RECEIVE AND FILE COMMUNICATION FROM THE PLAN AND ZONING COMMISSION REGARDING APPROVAL OF PRELIMINARY PLAT "GRAY'S STATION PLAT 1" FOR PROPERTY LOCATED AT 1300 TUTTLE STREET

| Description of Action   | Review and approval of a Preliminary Plat "Gray's Station Plat 1" to allow the property to be divided for a multiple family residential lot, two mixed-use lots, and 81 rowhouse or detached single-family dwelling lots. |              |                                       |              |      |

| <b>Description of Action</b>  |  | Review and approval of a PUD Development Plan for "Gray's Station Phase I" to allow development of 81 rowhouses and single-family dwelling as required by the Gray's Station PUD Conceptual Plan. |              |  |              |

HRC NFS I, LLC, Gray's Station Plat 1, Vicinity of 1300 Tuttle Street 13-2018-1.39

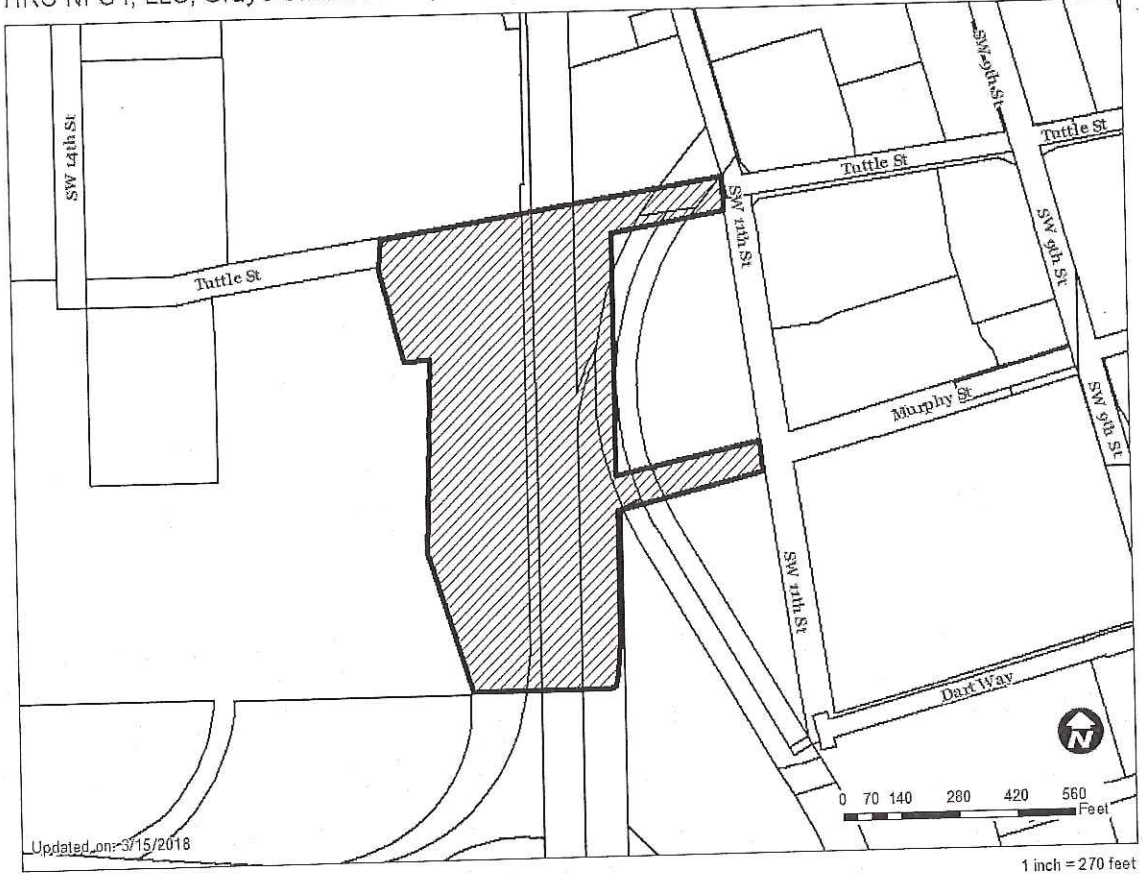
**APPROVAL** of the submitted Preliminary Plat subject to the following conditions:

1. Compliance with all administrative review comments of the Permit and Development Center.
2. All necessary storm water management facilities, on- and off-site, shall be operational to the satisfaction of the City Engineer before a Temporary Certificate of Occupancy (C.O.) may be issued and must be fully construction before a Final C.O. may be issued.

3. The plat name shall be revised to "Gray's Station Plat 2."

HRC NFS I, LLC, Gray's Station Phase I, Vicinity of 1300 Tuttle Street 10-2018-7.89

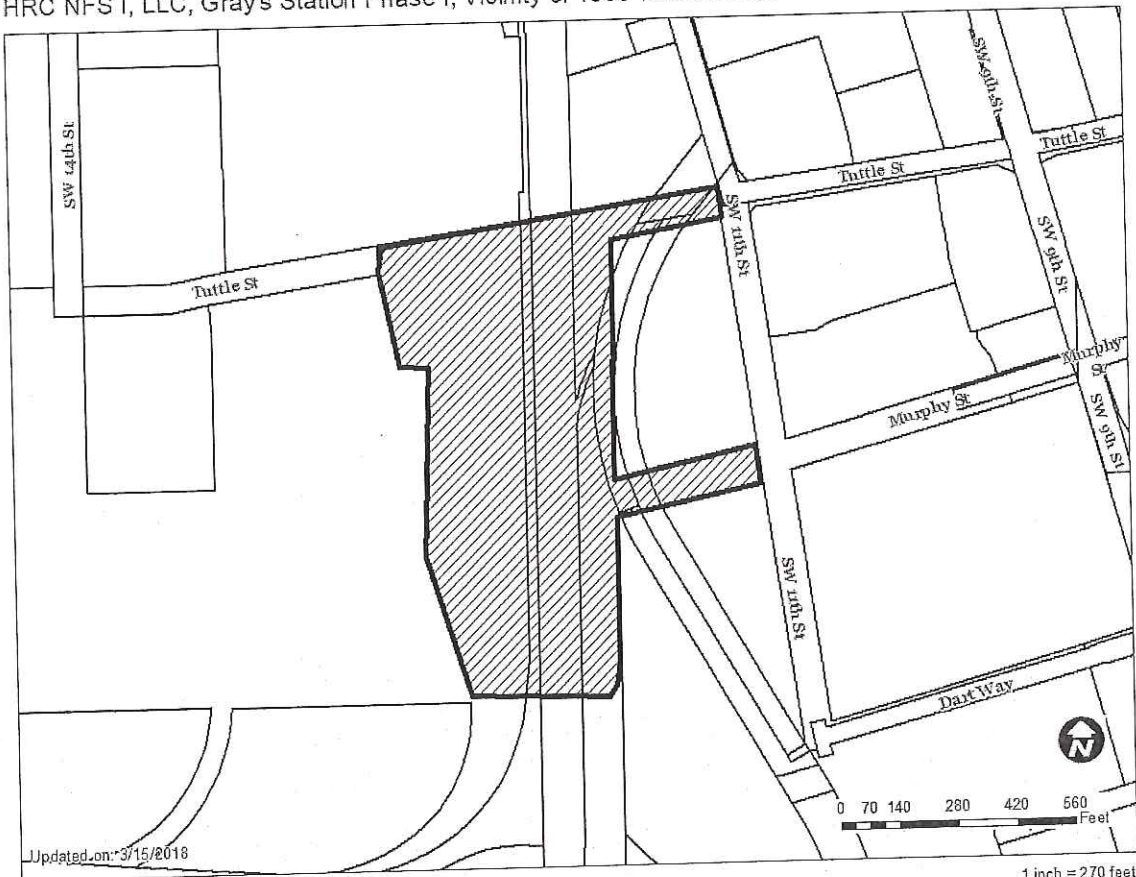
AND approval of the proposed PUD Development Plan subject to the following conditions:

1. Compliance with all administrative comments of the Permit and Development Center.
2. All site lighting shall be directed downward and shielded from adjoining properties. Any pole mounted lighting along private walkways shall not exceed 15 feet in height and any pole mounted lighting in a parking area shall not exceed 20 feet in height. These standards do not apply to light art installations that are determined to be in compliance with the PUD Conceptual Plan by the Planning Administrator.

3. All necessary external mechanical equipment shall be roof-mounted and screened on any side that fronts a public street, trail, or green space with an architectural extension (e.g., parapet wall) of the building. Equipment may be ground mounted along alley and internal side facades if the unit does not have a flat or low-sloped roof.

4. All utility meters, transformers, and other utilities shall be placed along internal side or rear facades of the buildings.
5. Review and approval of finalized building elevations and materials by the Planning Administrator.

6. Review and approval of finalized building elevations and materials by the Planning Administrator.
7. ~~The submitted building designs shall be modified to address the following:~~

| H | Type 2, 2.1 & 2.2 | Front         | One or more of the fiber cement board panel sided building planes shall be sided with metal panels or masonry.   |
| I | Type 2, 2.1 & 2.2 | Sides & Rear  | These facades shall be altered to include metal panels or masonry that corresponds to the changes made per item H.   |
| J | Type 2.1 & 2.2    | All           | The rooftop access house shall be side with metal and the side facades shall be altered as necessary to tie into this change.  |
| K | Type 3B           | Front         | The 2-story stone element of the end units shall be sided with brick and the portion of the facade below the 2 <sup>nd</sup> floor balcony of the end units shall be sided with stone.                     |
